Re: The Square, 4 Church Street, Spalding (Gamlyn Almshouses)

Project: Gamlyn Almhouses Spalding

Requirements: Stonework Report with various areas of the Dressed Masonry of the Gables and internal elevations.

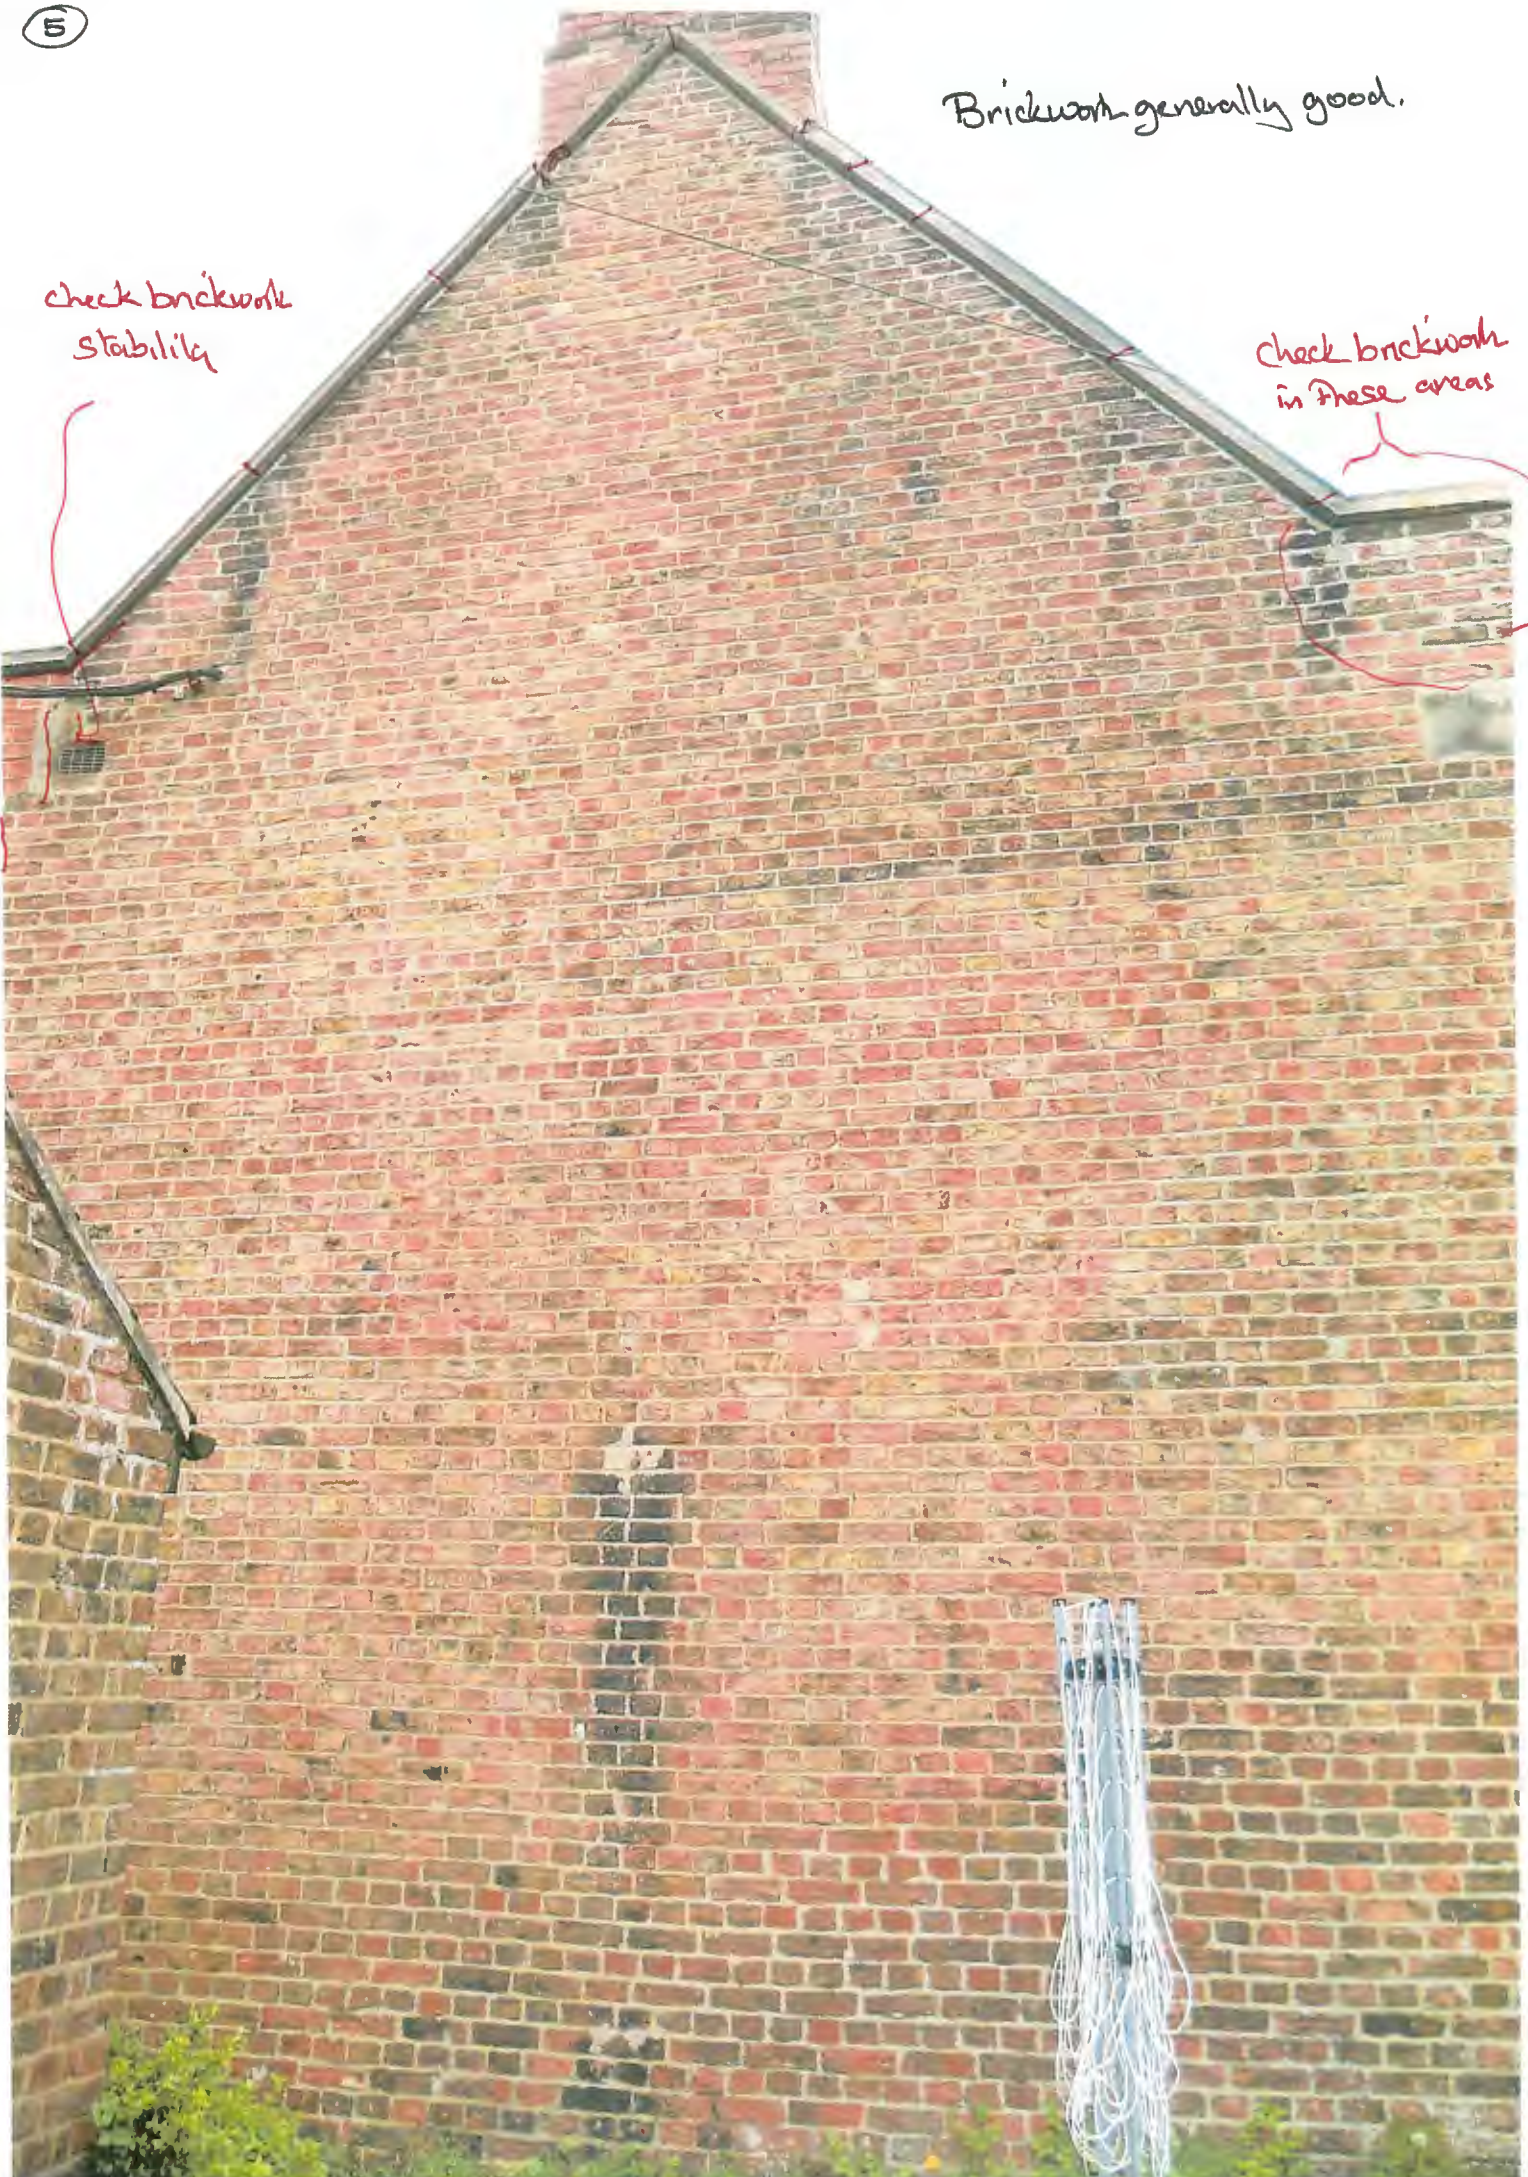
Brickwork to Gable generally good
Allow Provisional 1 sq mtr
of open joints to scattered and
individual open joints for repoint.

check stability

②

Brickwork to gable end good
but allow for any random or
individual open brick joints to
be repointed Provisional Intersay
allow

check these
brick areas to all

check brickwork
above corbels for
stability.

replace
